Office Action Summary	Application No. 10/767,225	Applicant(s) KUO, YI-LUNG	
	Examiner Noah C. Hawk	Art Unit 3636

DETAILED ACTION

Della Fiora '822, Figure 2B

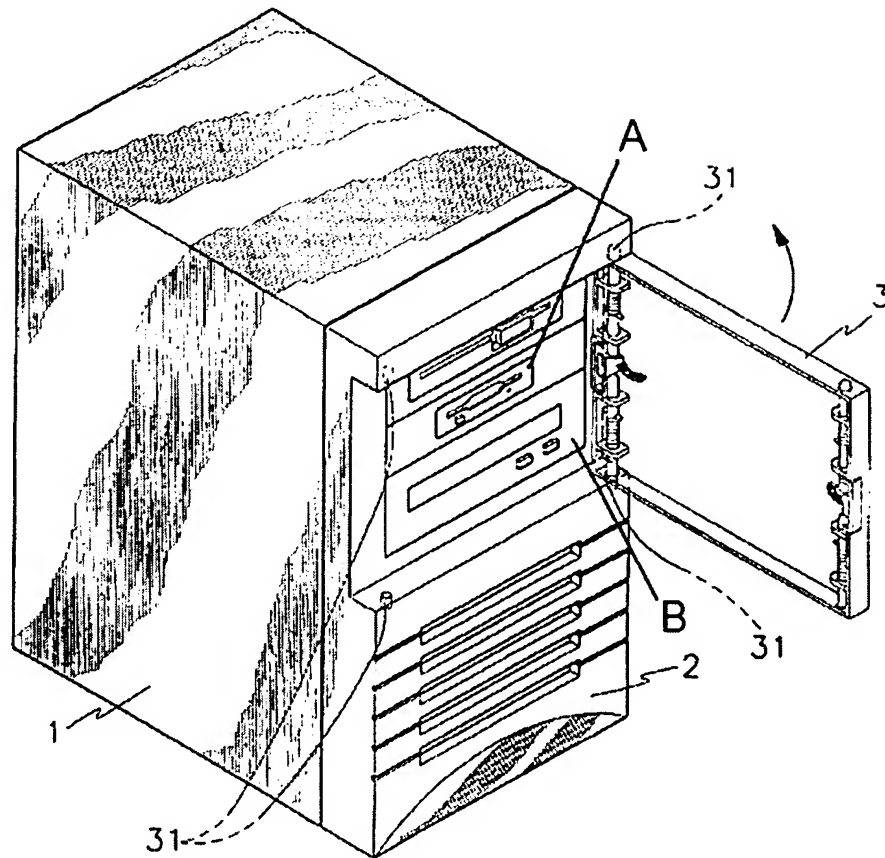
10. Claims 1, 4 and 8 are rejected under 35 U.S.C. 103(a) as being unpatentable over Della Fiora et al. in US Patent 6130822 in view of Dong in US Publication 2002/0027771. Della Fiora teaches a face plate apparatus comprising an opaque cover plate (26) having a window (A) and a mechanism (42 and 44) for rotatably coupling the cover plate to a computer chassis. Della Fiora fails to teach a drive door to cover the window. Dong teaches a drive door (14) covering a window (12) in a cover plate (10) to further protect the drives underneath. It would have been obvious to one of ordinary skill in the art at the time of invention to modify the device of Della Fiora by adding drive door as taught by Dong in order to further protect the drives under the cover plate.
